RESPONSE TO IDEM RWP RESPONSE TO COMMENTS & ADDENDUM I REVIEW

MICHIGAN PLAZA
3801-3823 WEST MICHIGAN STREET
INDIANAPOLIS, INDIANA

IDEM INCIDENT NUMBER: 0000198

JANUARY 16, 2009

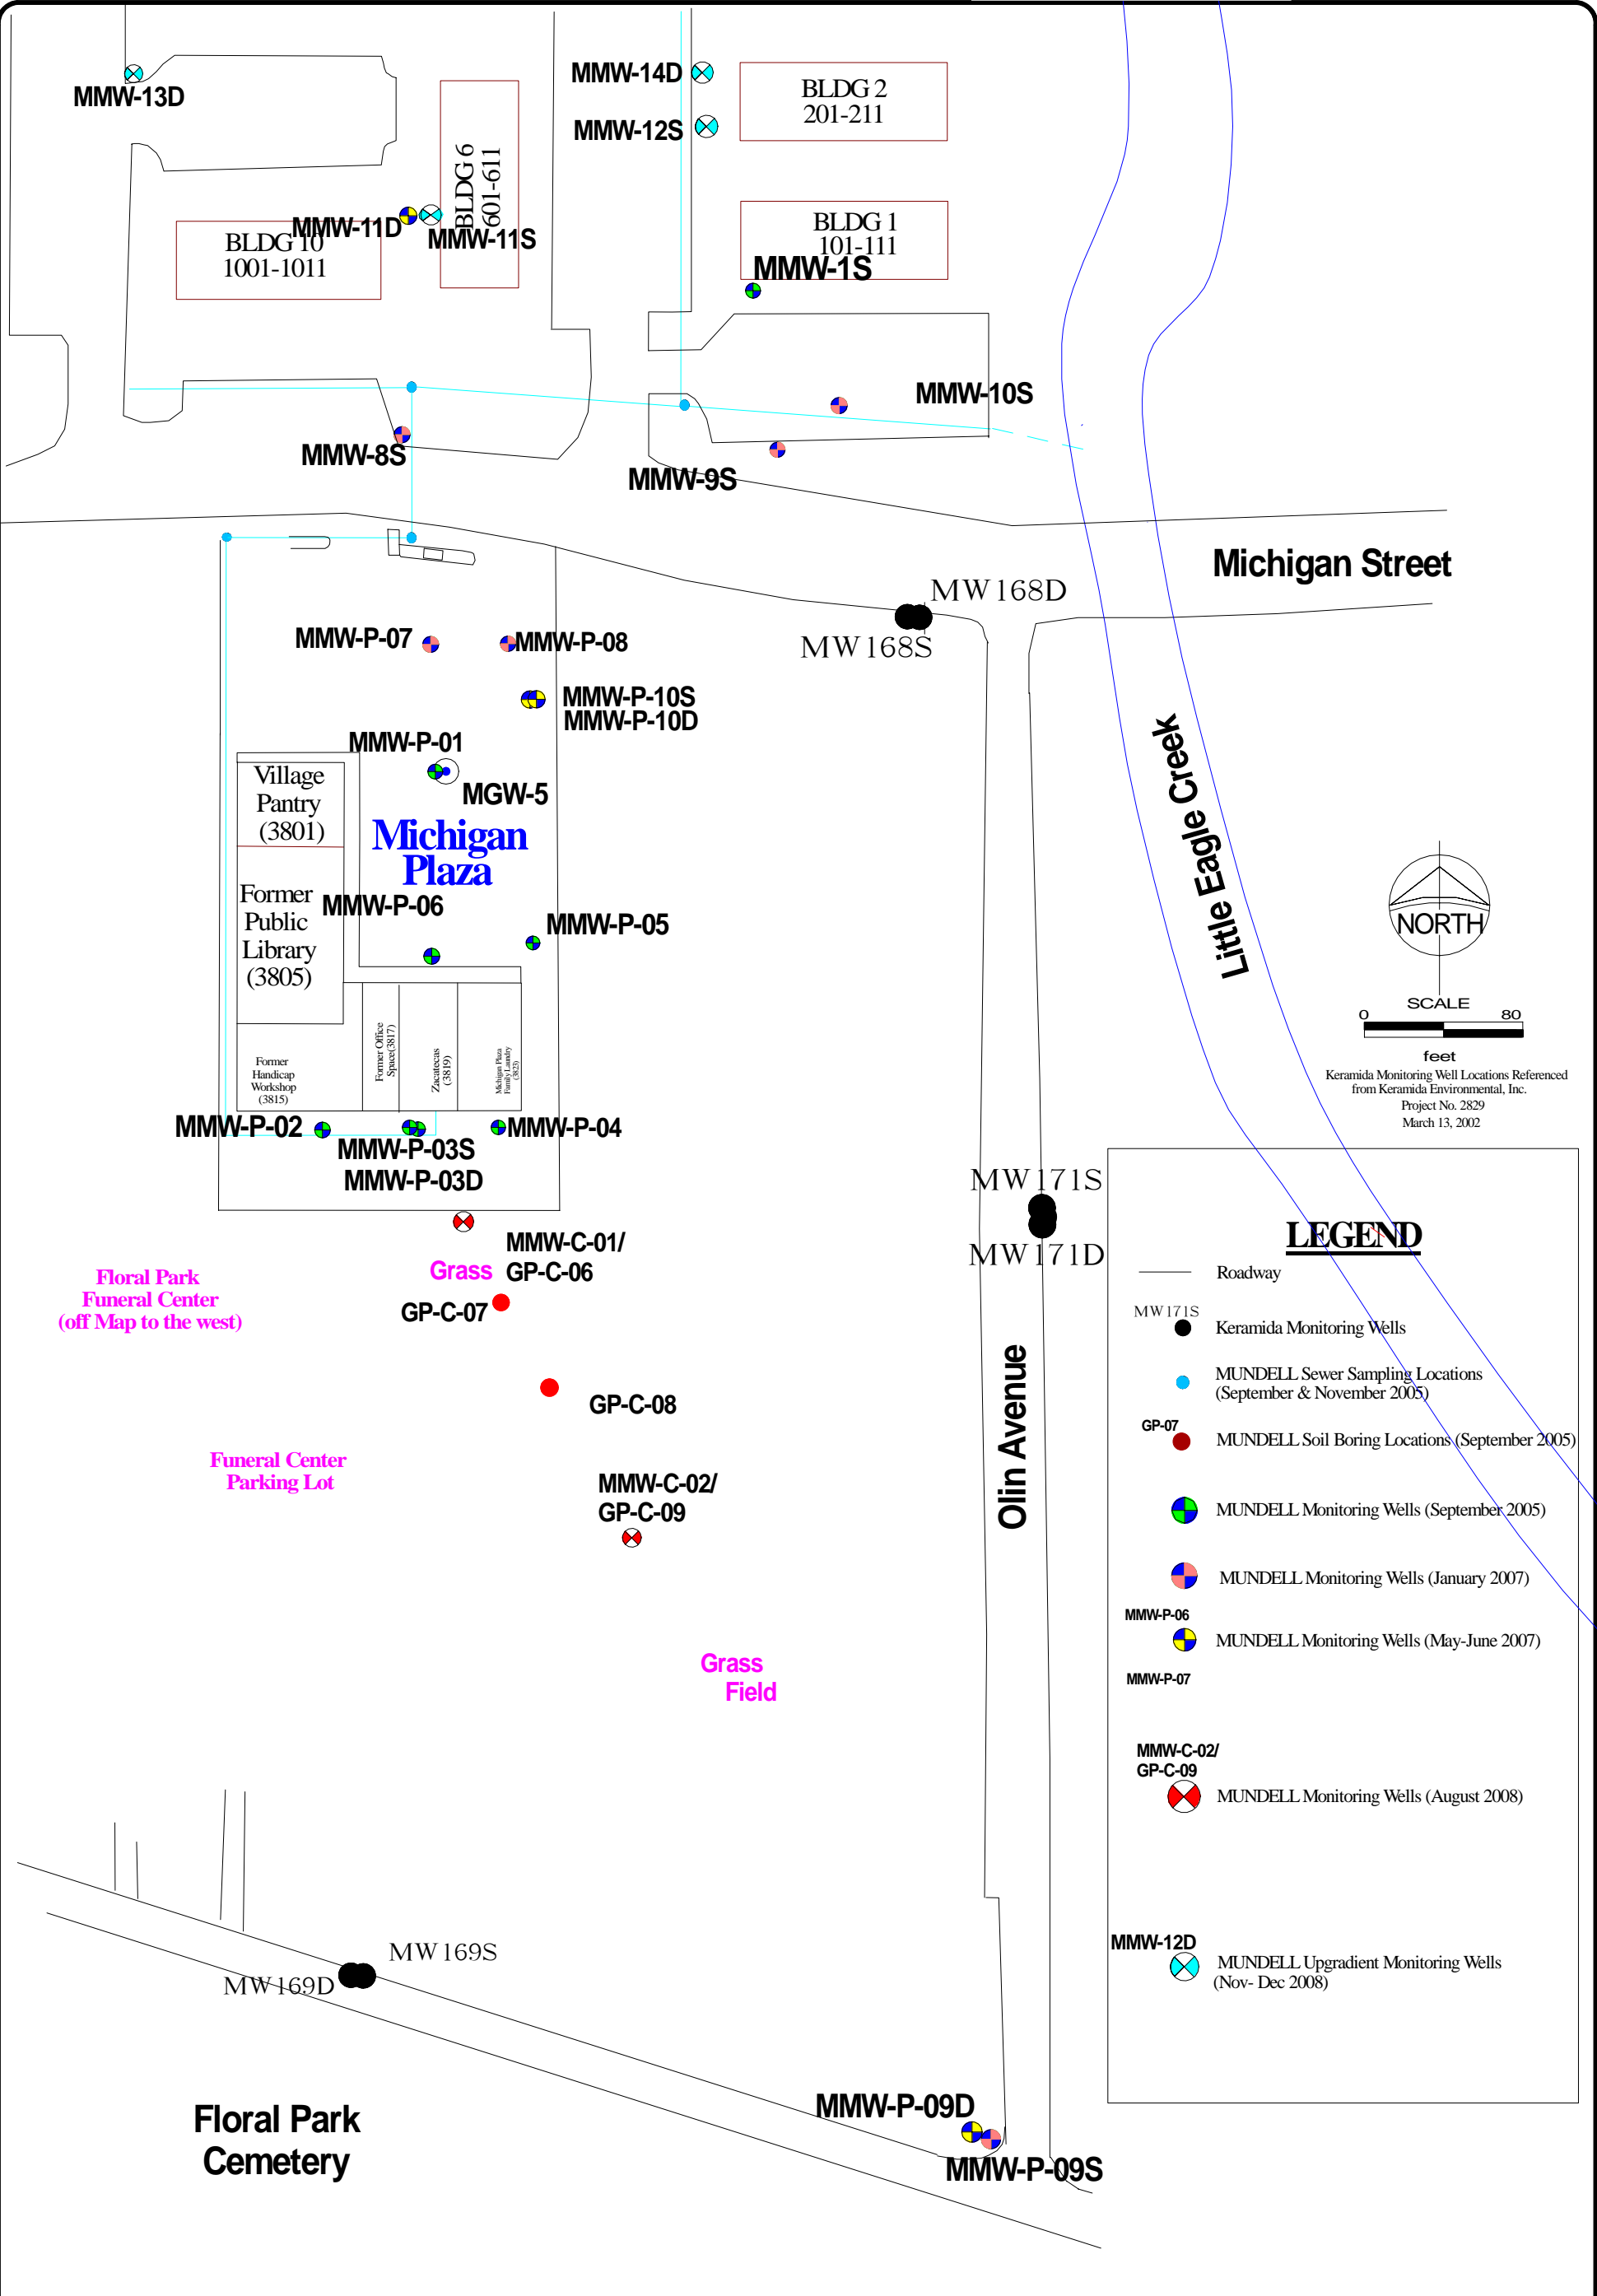
IDEM Comment No. 9. Response 8: The proposal to install two up-gradient deep wells rather than the three initially suggested by IDEM is generally acceptable. However, both wells are planned to be at least 100 feet up-gradient of the known sources of shallow contamination. Deep wells should be within 20 feet of the known source areas.

MUNDELL Response: Monitoring well MMW-11S is in the range of 20 to 30 feet from the plume (*Source Area B*, see attached **Figure 1**). The clay till isopleth map (*Refer to Fig 44 from the RWP*), indicates the hard pan (ranging from 32 to 37 feet in the area) represents the base of the aquifer and limited the depth of installation of MMW-11S. Hence, MMW-11S (screened from 23 to 33 feet to top of till) is essentially a deep well and is renamed MMW-11D.

Nearest Property/Receptor Location

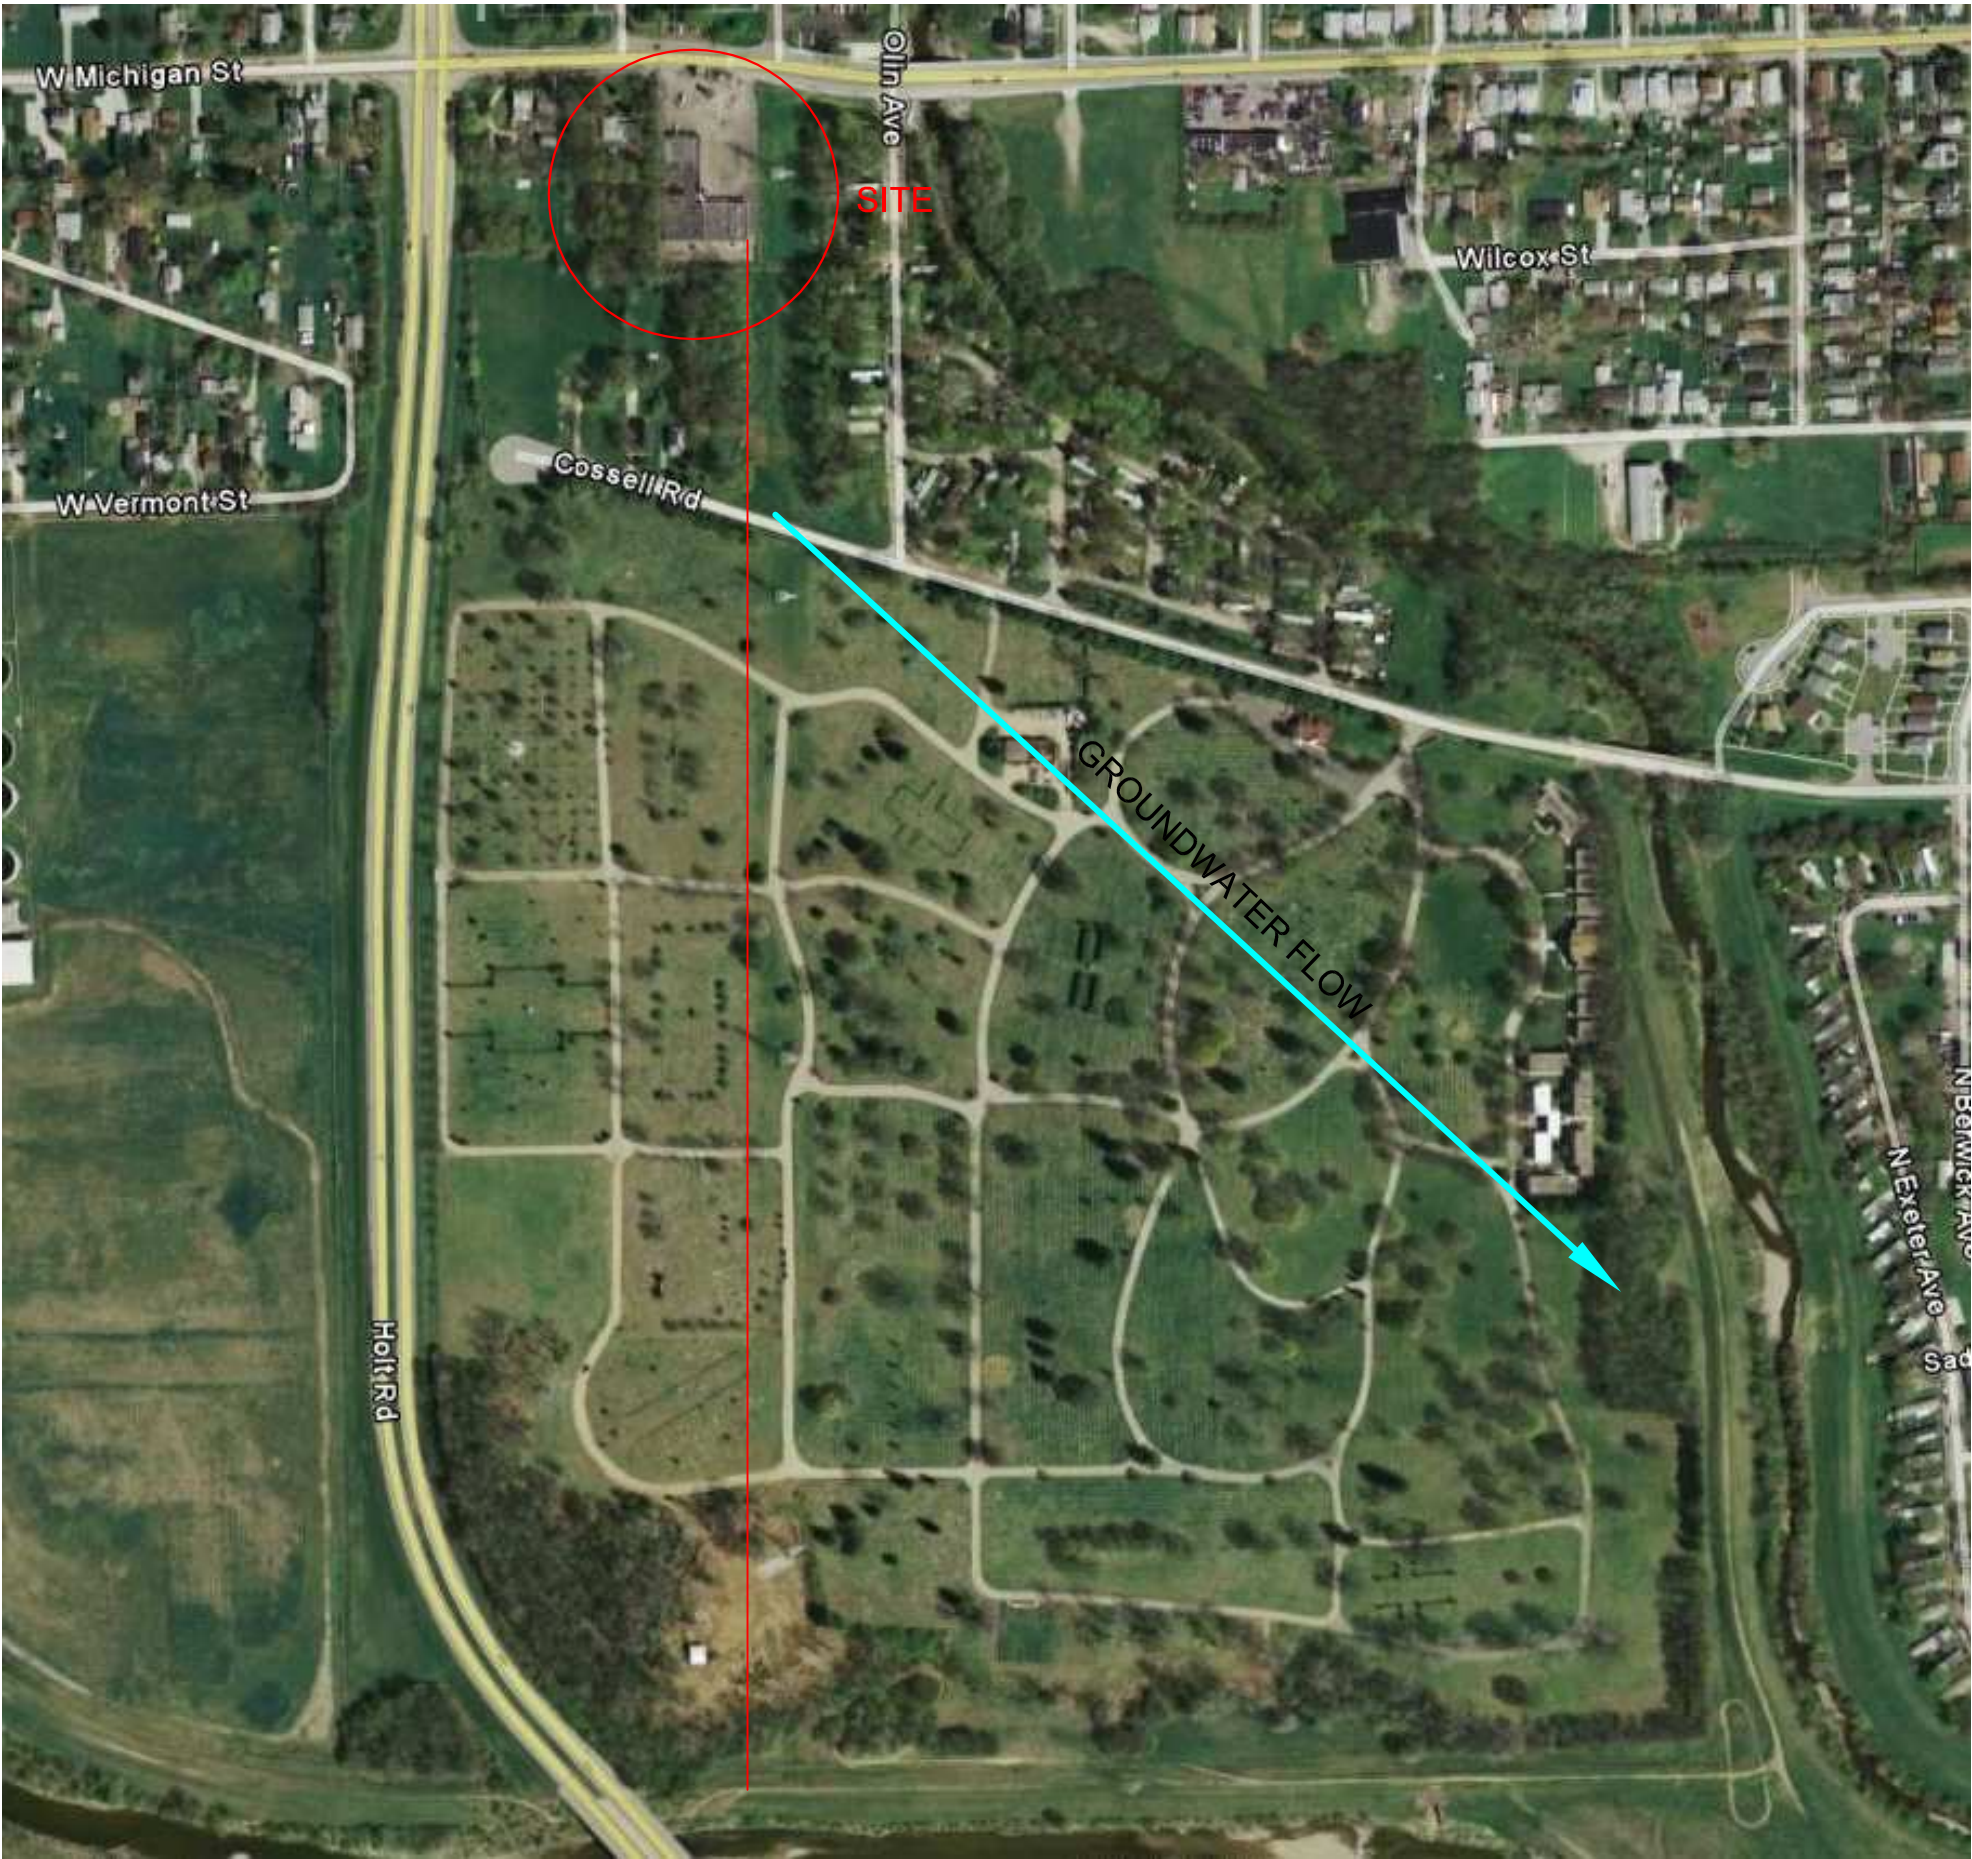
IDEM Comment No.11. Please be advised that a sampling event south of Cossell Road or south of the Floral Park Cemetery property is necessary to fully delineate vinyl chloride in the groundwater. As of September 2008, the vinyl chloride in well MMW-P-09D was 72.6 ug/kg, which is above both the residential and industrial RISC closure levels. The extent of contamination needs to be defined to RISC residential default closure levels. The IDEM is willing to send correspondence to the Floral Park Cemetery property owner should you require assistance for off-site access.

MUNDELL Response: MUNDELL believes that the groundwater impacts observed in the deeper aquifer just north of the downgradient cemetery property represents a unique setting that does not currently represent a threat to human health or the environment (*i.e.*, a very large

cemetery property extending further south of Cossell Road with no receptors within 1,800 to 2,000 ft; see **Figure 2** for the nearest property/receptor information). In addition, MUNDELL believes the deeper aquifer impacts are currently being evaluated with the installation and testing of the new upgradient wells to determine whether they are attributable to Genuine or Michigan Plaza. MUNDELL recommends that we notify Floral Park of the existing groundwater impacts, and work toward gaining access to their property to determine where acceptable future monitoring locations are possible.
